Plan Change 7 – Technical Planning and Infrastructure Report

Rotokauri North Proposed Private Plan Change 7

Report on technical planning and infrastructure matters relevant to Hamilton City Council

Report Author: Paul S Ryan, Principal Planner, City Planning Unit, Hamilton City Council

Draft Plan of the Proposed Minor Arterial (D-3361662)

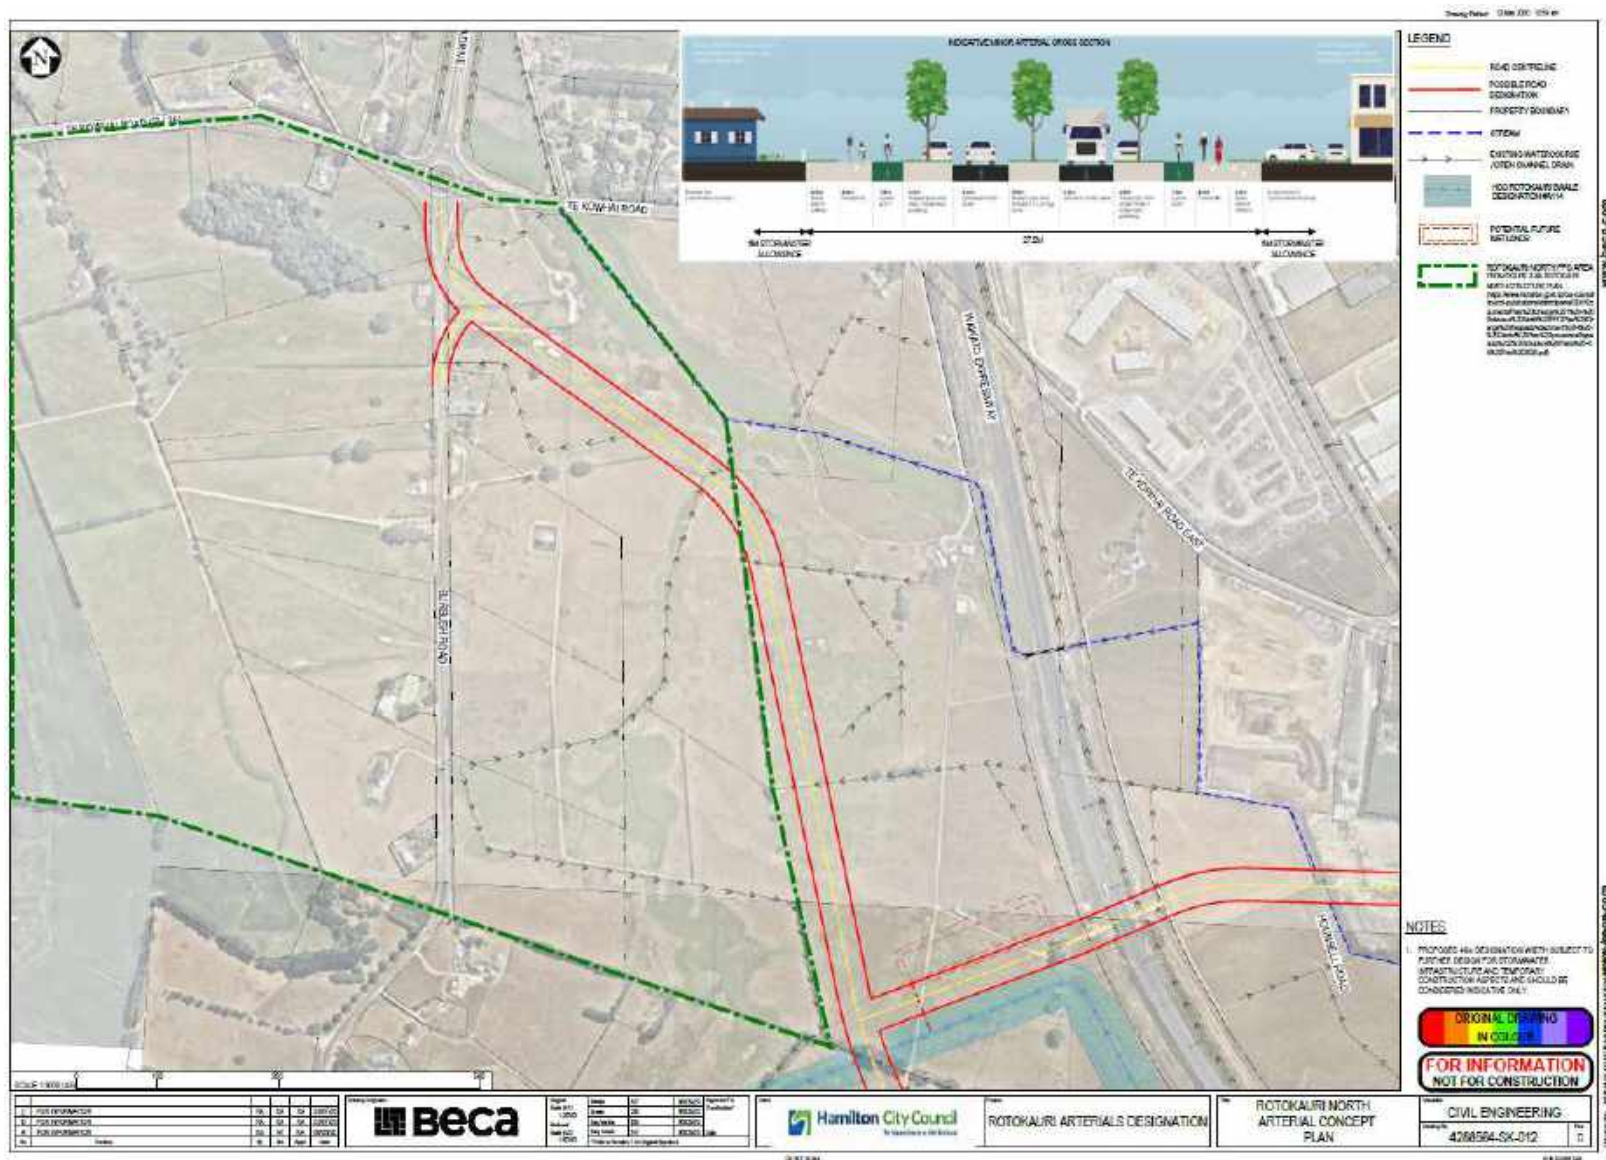
- (4) If, prior to hearing PC7, the team preparing the notice of requirement for the minor arterial provide an updated alignment for the minor arterial designation, it is recommended that the updated alignment be used as the basis for Figure 2-8A. Otherwise, it is recommended Figure 2-8A be based on the alignment shown in Appendix 4.¹¹⁴

Figure 3 Possible public transport routes to service Rotokauri and Hamilton West

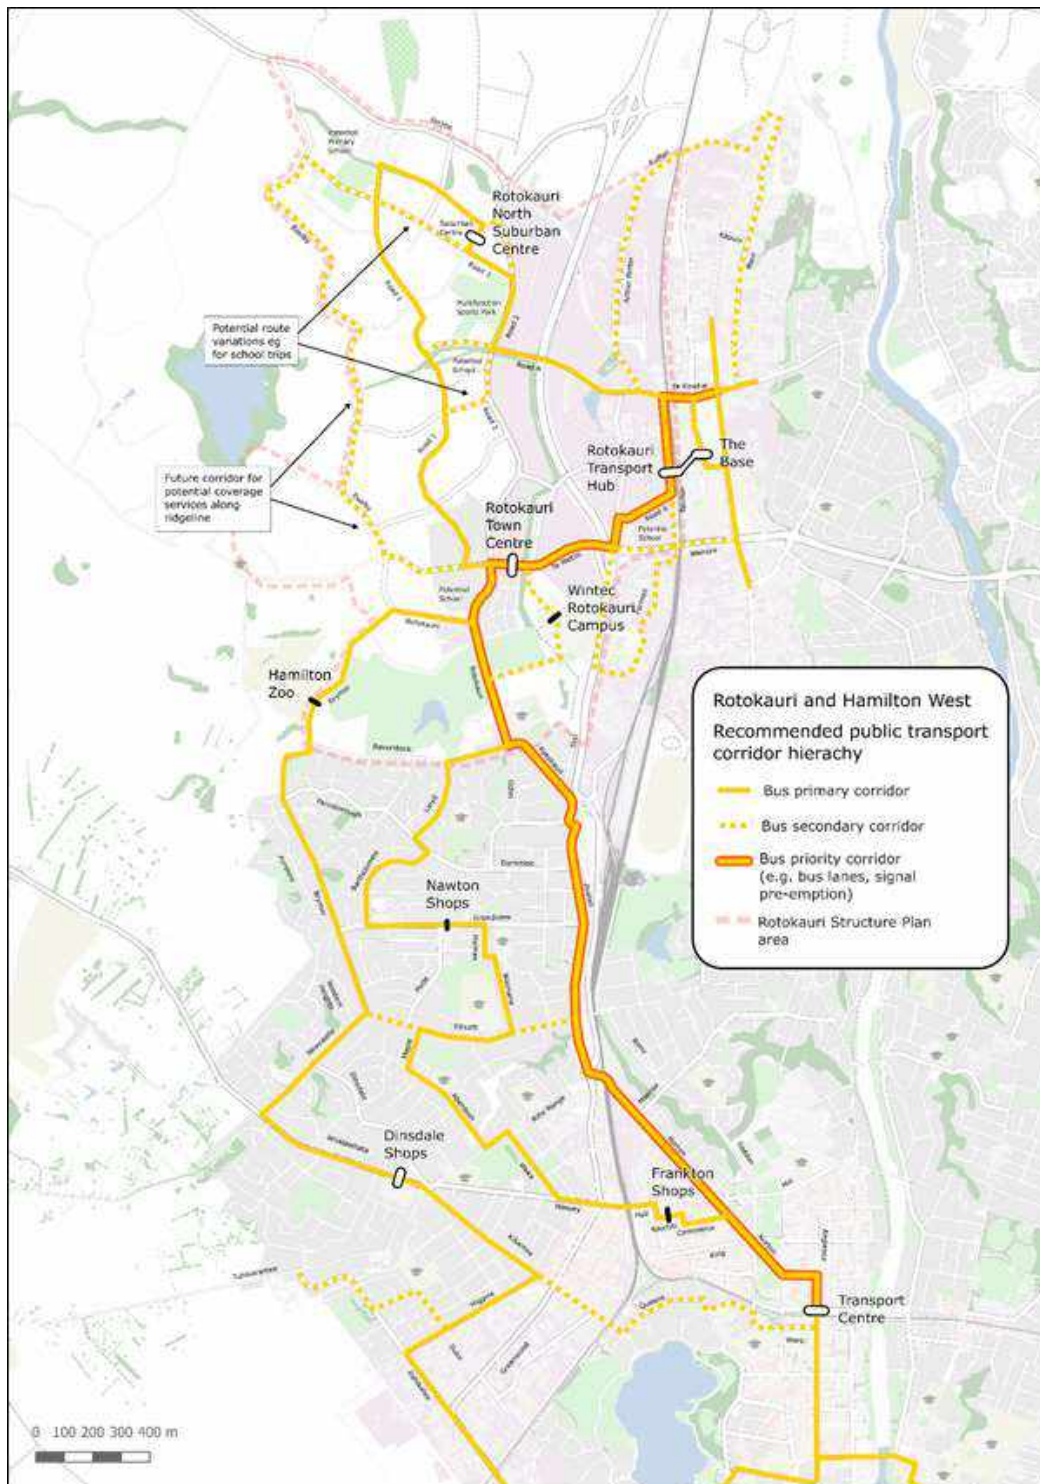
On 19 February 2021, Andrew Carnell, Team Leader – Network Planning and Performance, Waikato Regional Council provided Figure 3 in Appendix 5. He advised that the Regional Council has yet to determine the preferred option for Rotokauri North; this is still a “work in progress”. He also provided detailed maps of 4 options for servicing Rotokauri North – see Figures 4 to 7 in Appendix 5.

It is recommended that, prior to the hearing, the Requester, Waikato Regional Council and Hamilton City Council work together to determine the best public transport option for Rotokauri North and show it on Figure 2-9C.
